## VANTAGE VIEW-E. BROADVIEW TO HILLCREST (ALLEY)

Solicitation Number: CO-00188

### ADDENDUM 2

July 24, 2018

SEWER PLAN - LINE "A"  
 STA 25+00 TO STA 28+10.08

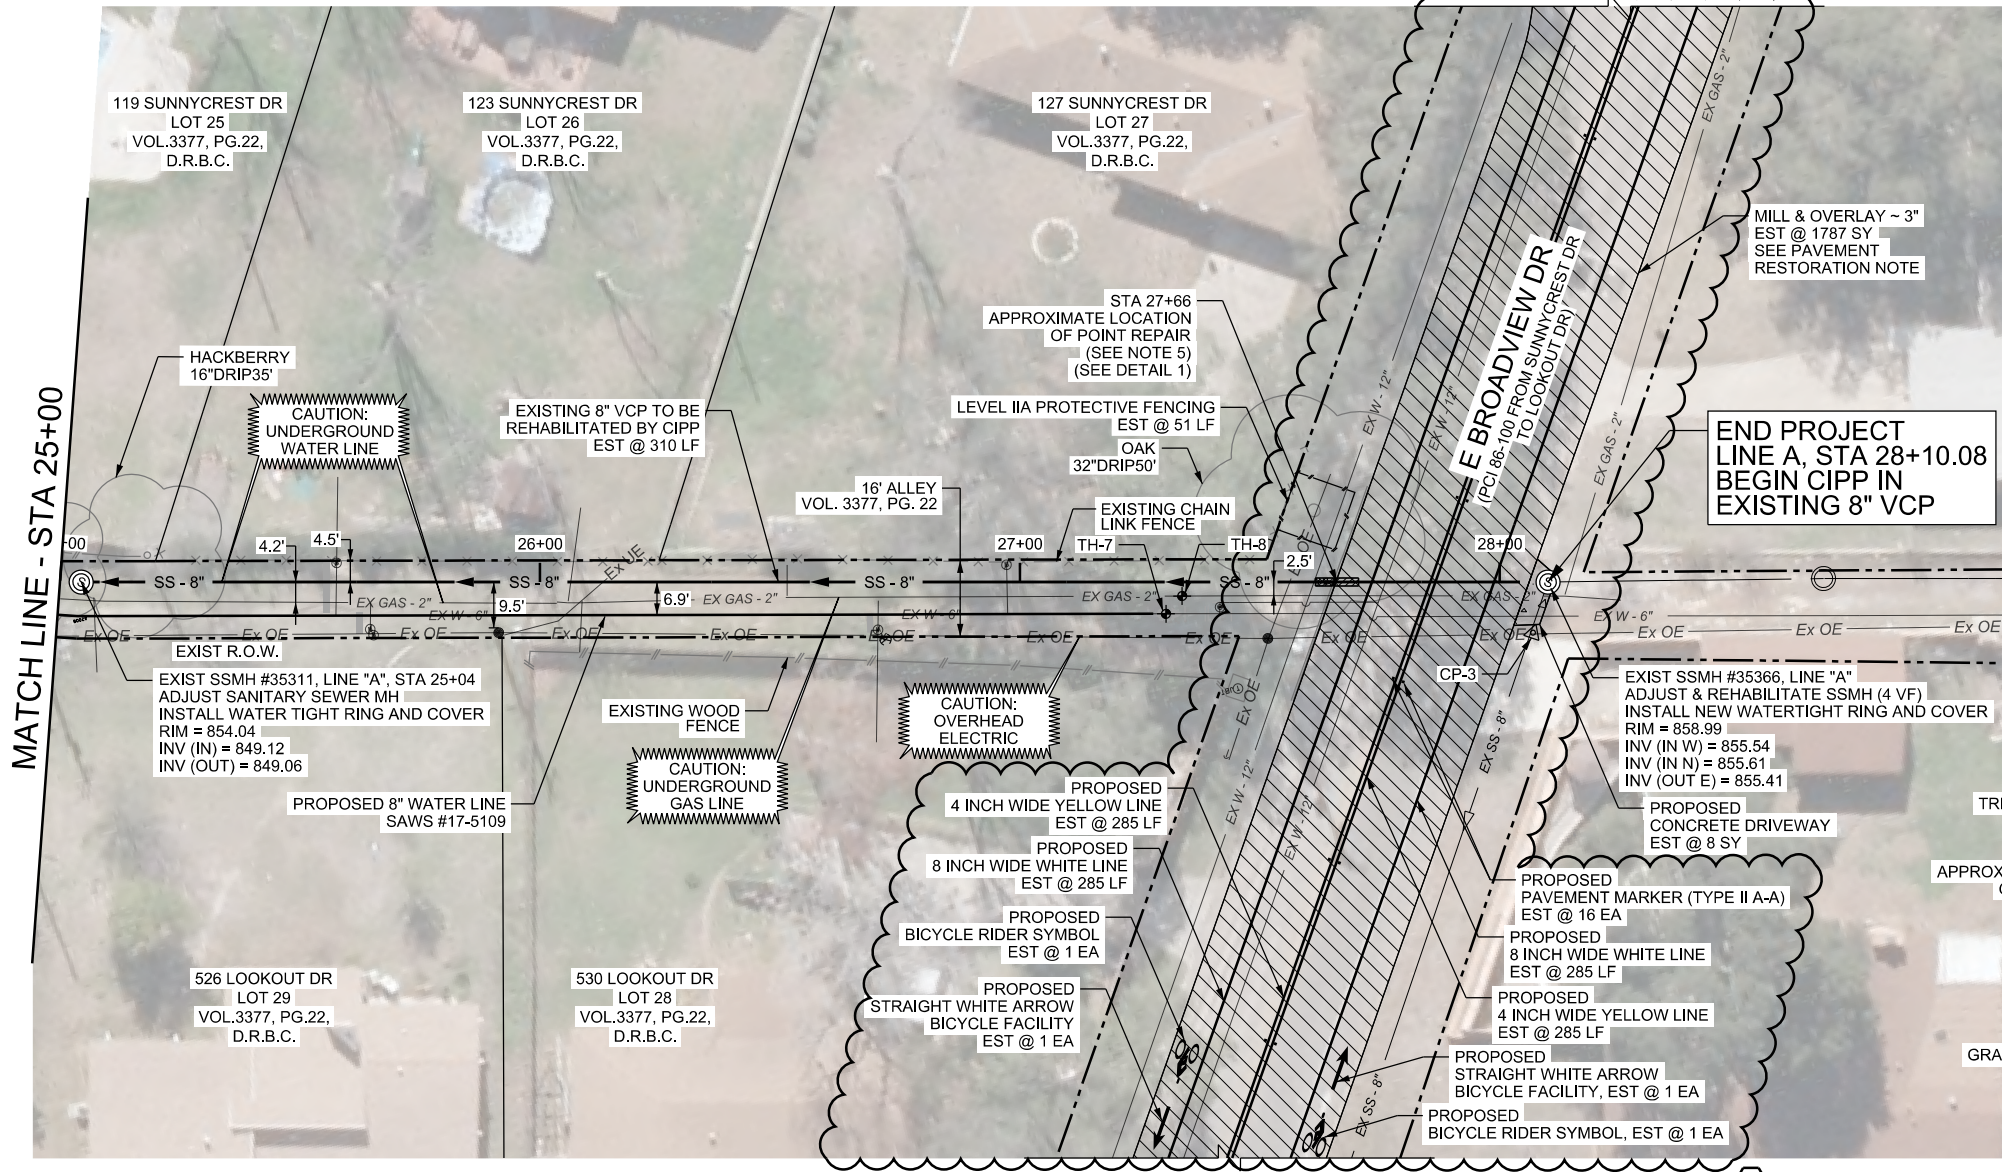
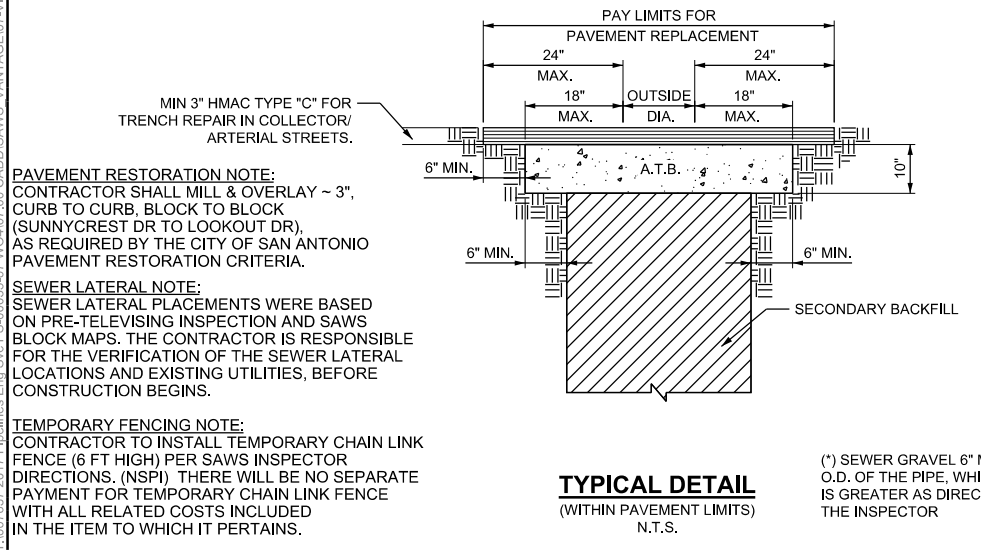
1. Sewer General Notes Sheet 2 of 13 - Added COSA Item No.'s 535.1, 535.4, 535.16, 535.17 and 537.8 and quantities.
2. Sewer Plan Sheet 9 of 13 – Added Pavement Markings on E Broadview Dr, and COSA Item No.'s 535.1, 535.4, 535.16, 535.17 and 537.8 and quantities.
3. The Sewer Project Estimate has decreased from \$456,413.00 to \$440,805.00 to reflect additional Pavement Marking Items and current SAWS Bid Tabulation Unit Prices.

ADDENDUM 2 (07-24-2018) - ADDED PAVEMENT MARKINGS ON E BROADVIEW DR, AND COSA ITEM NO.'S 535.1, 535.4, 535.16, 535.17 AND 537.8 AND QUANTITIES.
